East Parcel

Proposed issues we should consider

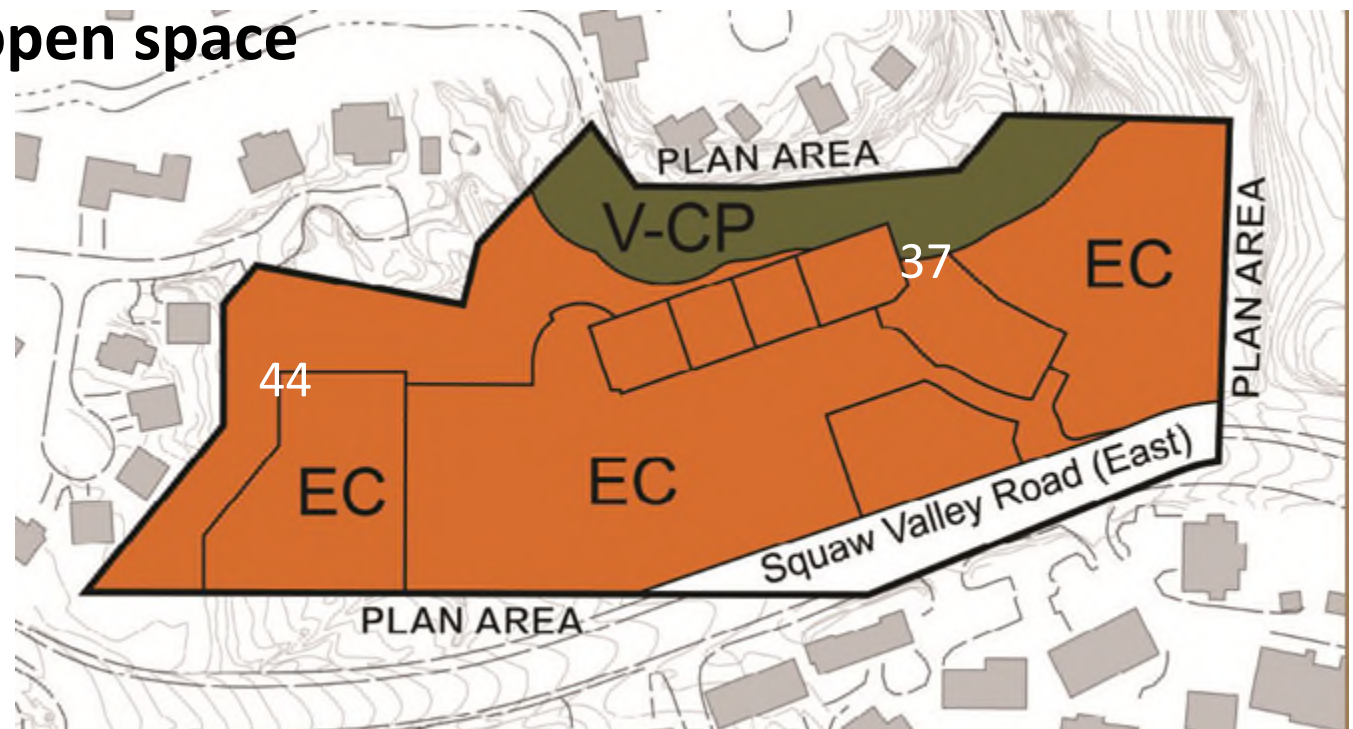
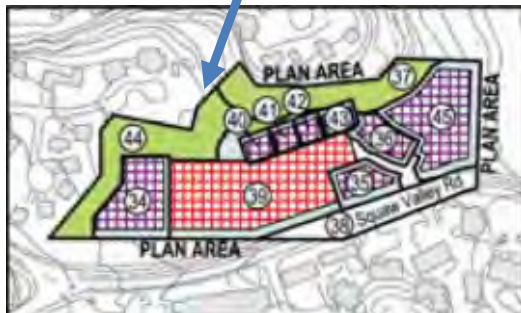
1. **What size and zoning is appropriate for the buffer between the East Parcel buildings and the neighboring homes?**
2. **Does the East Parcel comply with Layout standards?**
3. **Do any of the Mass, Scale, & Height Standards apply?**
4. **How to create an effective the buffer zone?**
5. **Can the bike path be altered a bit?**

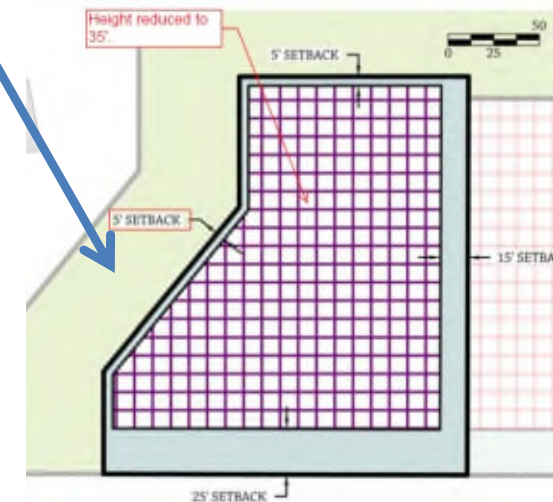
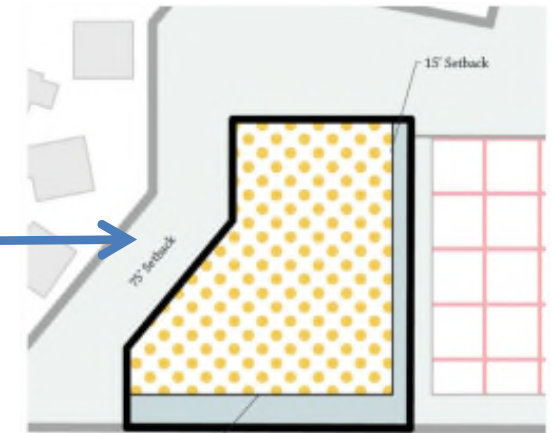
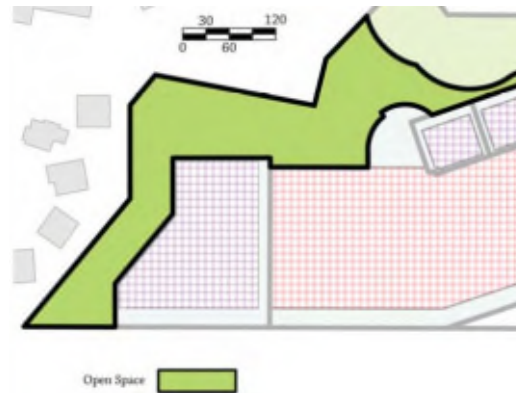
A parameter from a previous Lot 34 picture indicated that this buffer is 75' (setback from building to the boundary with the homes). It was removed.

Lot 44 measures this out at ~60'

What should be the minimum buffer dimension (shortest distance at any point) along the entire boundary of Lots 37 and 44?

2. Does East Parcel comply with Standard for paths/passageway?

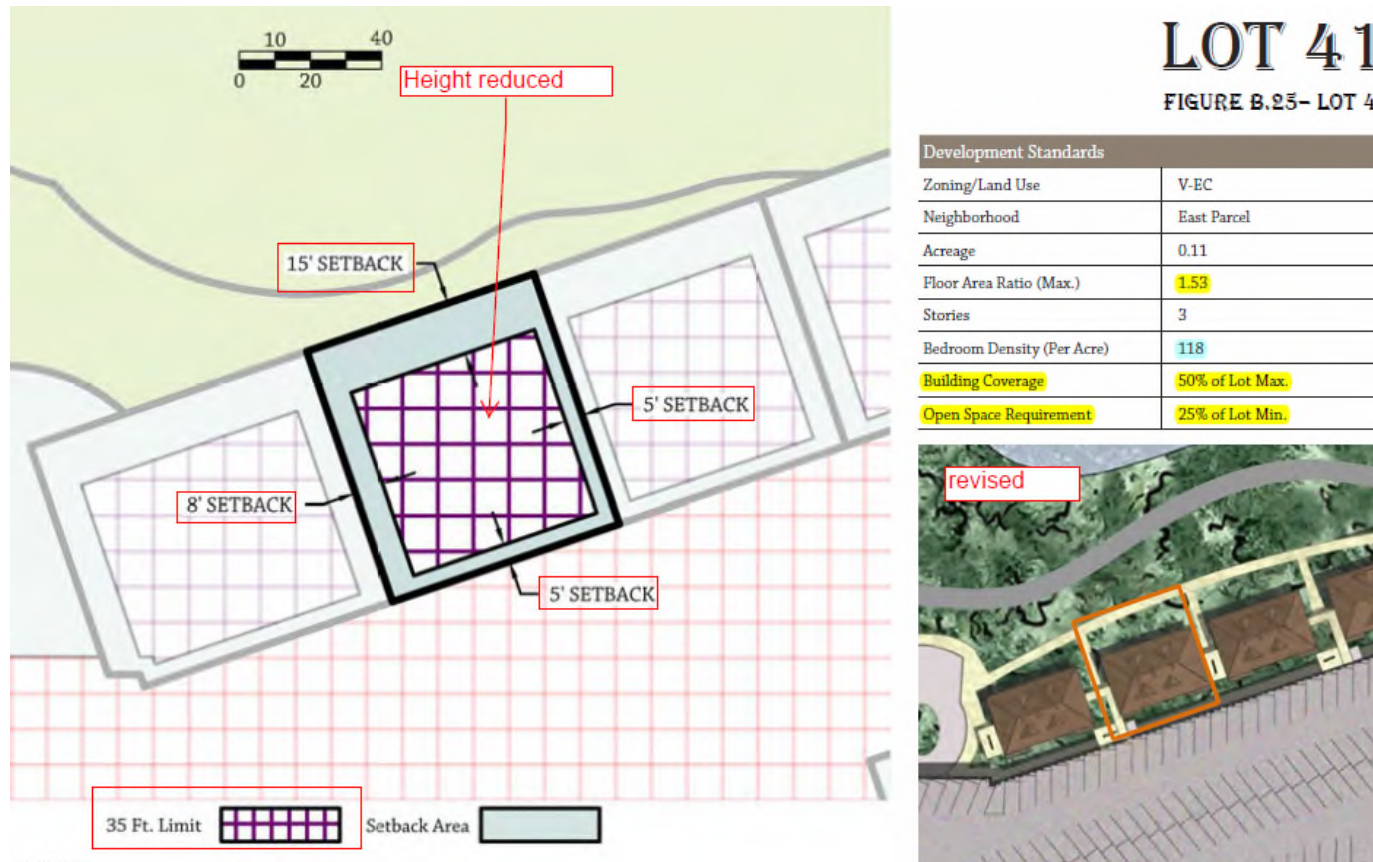
From the new details of Lots 40, 41, 42, 43 the buildings are 10' or 16' apart and only 5' from the parking structure. The proposed Standard for paths is 20'. The proposed standard is NOT met.

Is that important?

3. Do any of the Mass, Scale, & Height Guidelines apply?

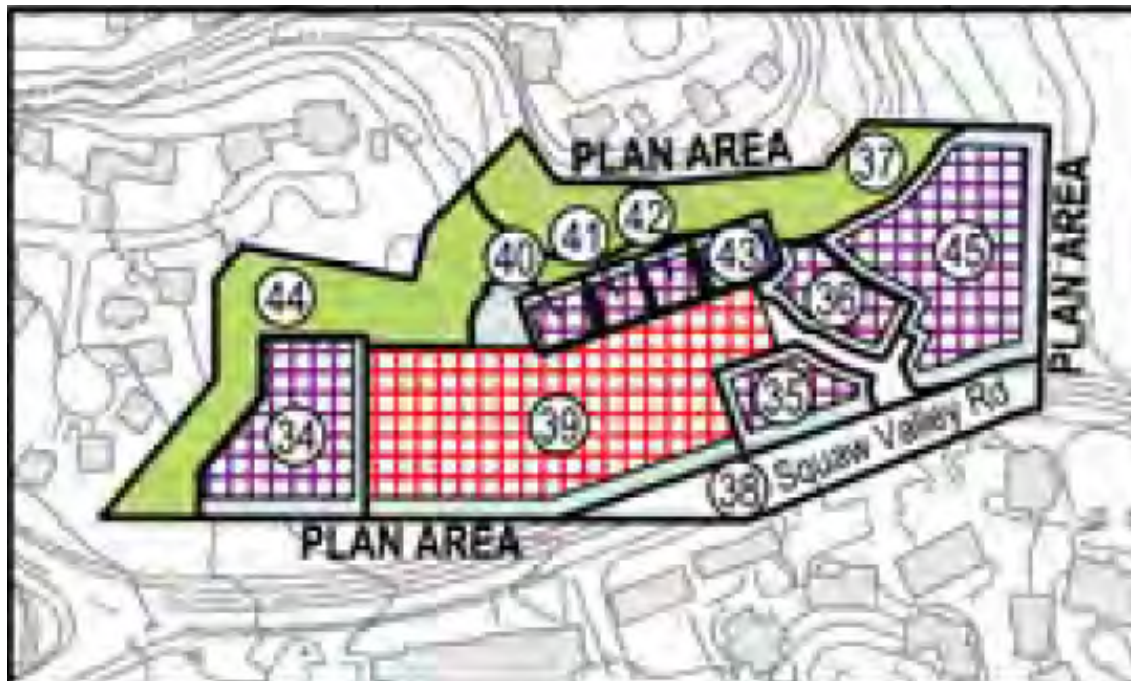
All the buildings are 35' max in this revised layout, which is under the 4 floor criterion.

There has been extensive fill on this land over time, but county is not in possession of any evidence of grading violations

5. What about the bike path through the buffer zone?

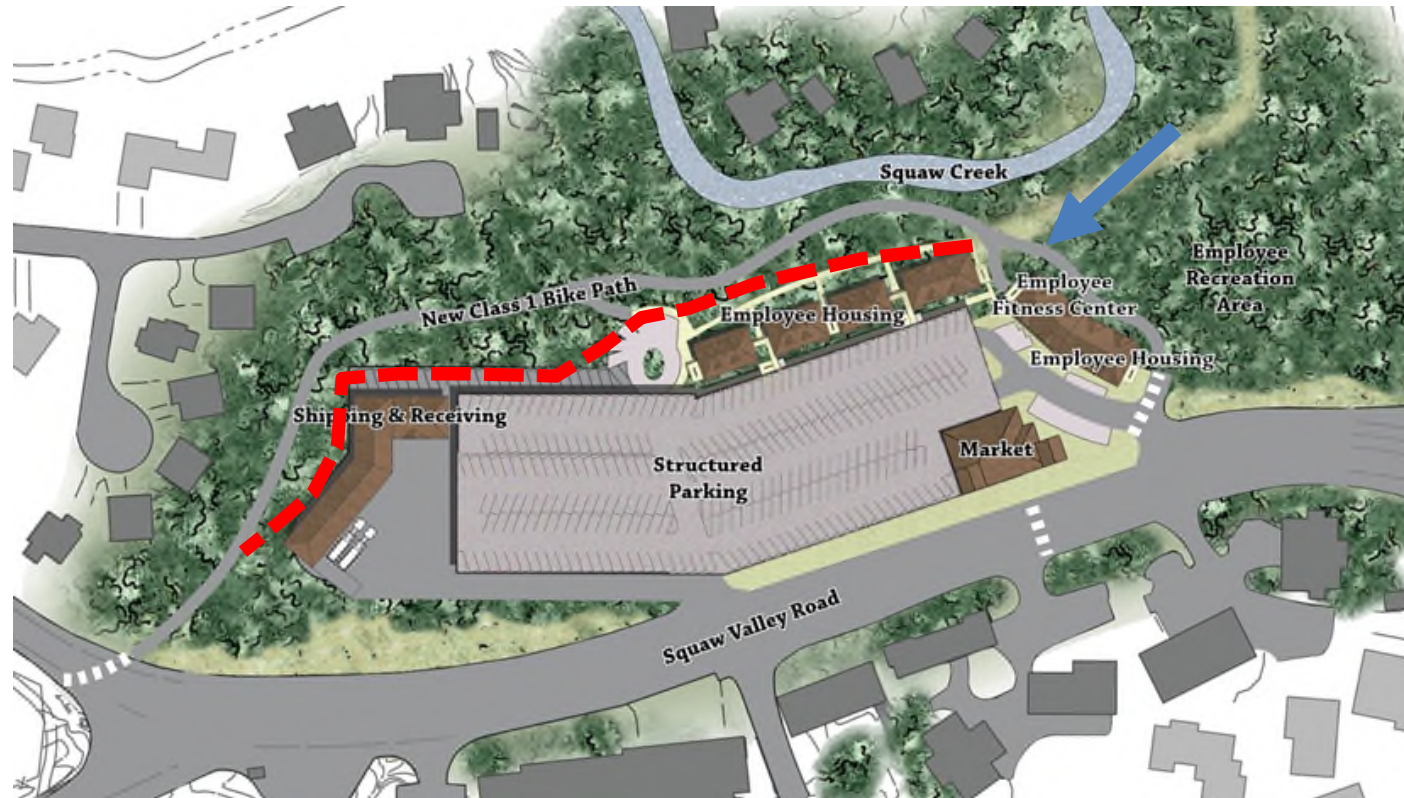
Can the bike path hug the buildings; move further from homes?
